PLANNING BOARD MEETING AGENDA

PLANNING BOARD MEMORANDUM TOWN OF BERWICK, PLANNING DEPARTMENT

TO: BERWICK PLANNING BOARD
FROM: JAMES BELLISSIMO, DIRECTOR OF COMMUNITY DEVELOPMENT & PLANNING
SUBJECT: CAF REALTY – ADULT USE MARIJUANA PRODUCTION FACILITY CONDITIONAL USE
DATE: AUGUST 18, 2020
CC: JENIFER MCCABE; PHIL SAUCIER

Re: Response and resubmission for CAF Realty Maine, Pond Hill Road

D2

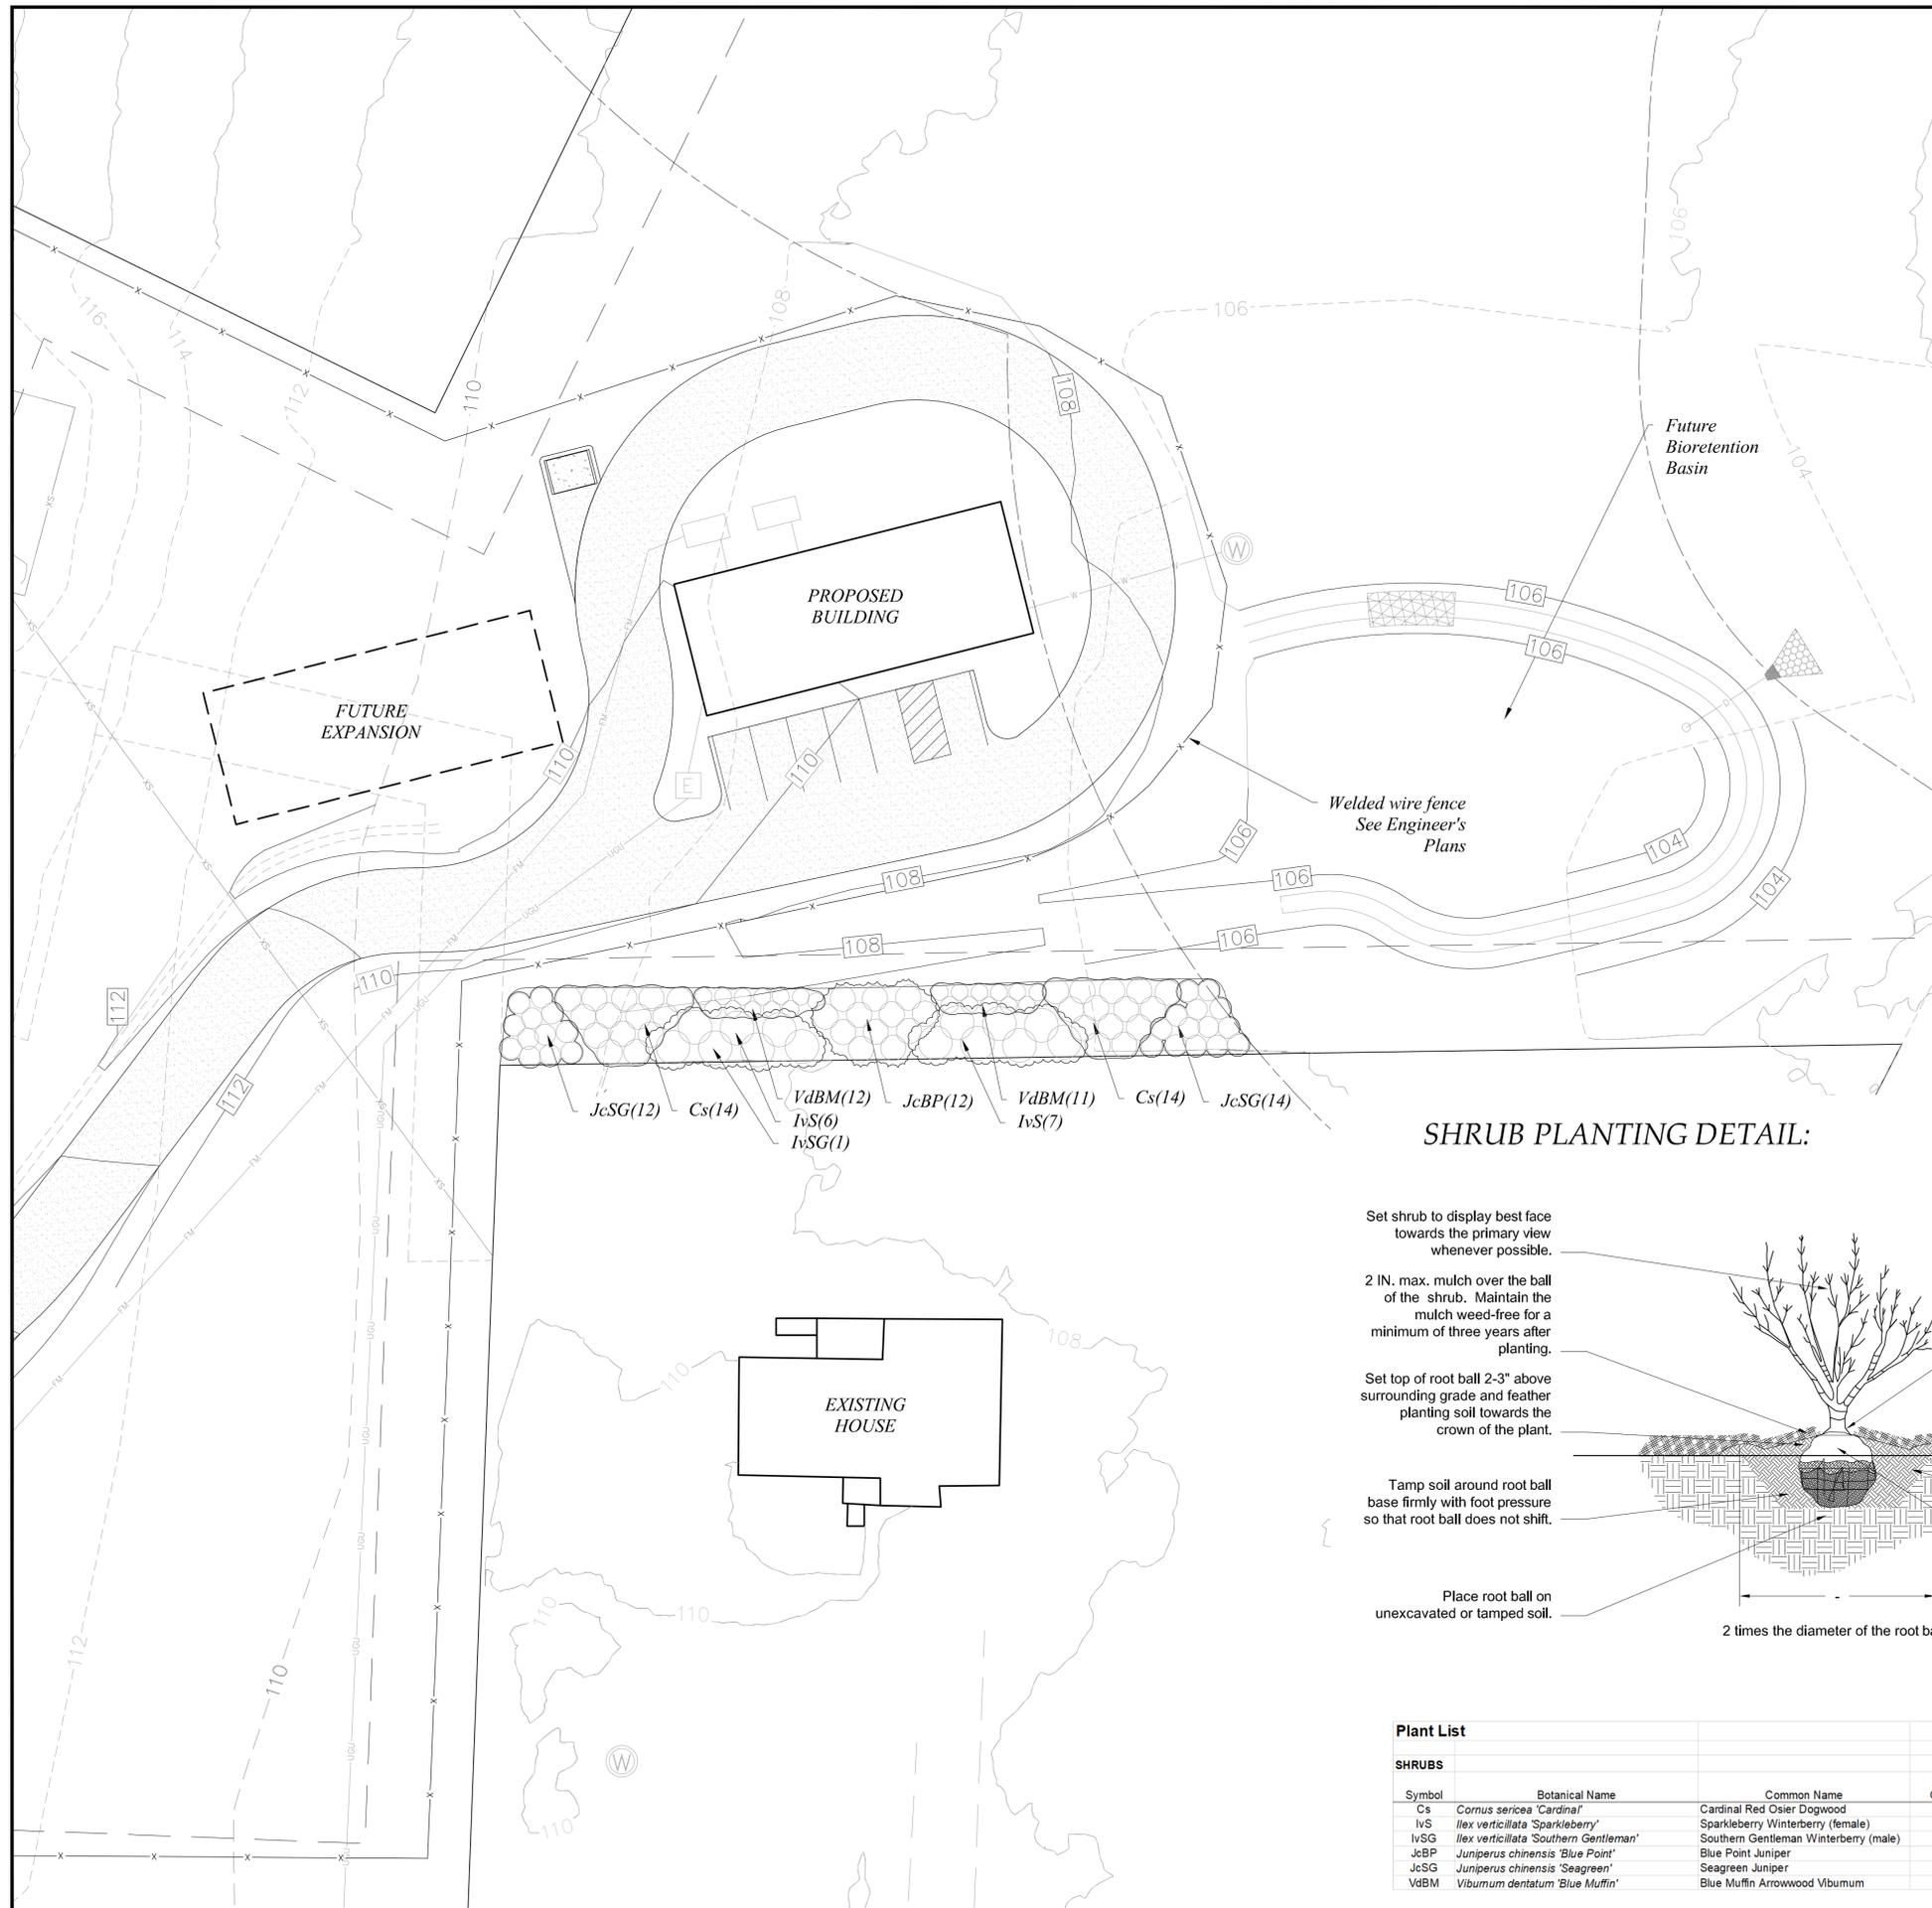
A future expansion building is now shown where an existing septic pipe easement is, this will have to be resolved before the Phase II building can be permitted. The access to the proposed Phase I building goes over the actual septic pipe. The plans for pipe protection are included in sheet D3.

1. A test pit will be performed where the proposed road crosses the force main prior to construction.
2. The thickness of insulation required has been added to the detail on sheet D3
3. Note 6 has been modified to refer to the sewer force main trench detail.
4. Encasement detail has been included in most recent plan set.
